## **Preliminary Review of the Eagle River Drop Structures**

**Prepared For: Eagle County Engineering**

**Prepared By: Recreation, Engineering and Planning, Boulder, Colorado**

TYPICAL DROP STRUCTURE  
NO SCALE

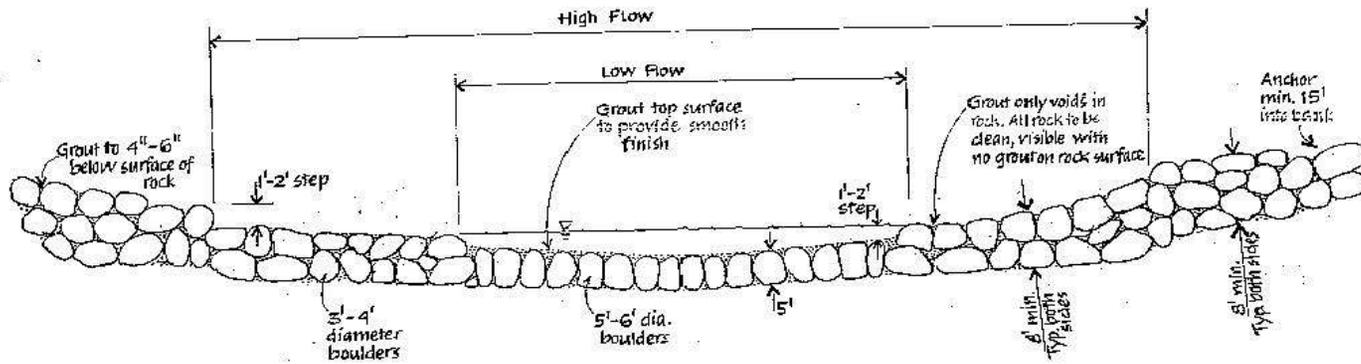
Attached are typical cross section and profile view of a “U” drop structure. The grout and temporary fills required to build coffer dams may require additional Army Corps of Engineering Section 404 permitting, and should be researched prior to construction of any in-stream enhancements.
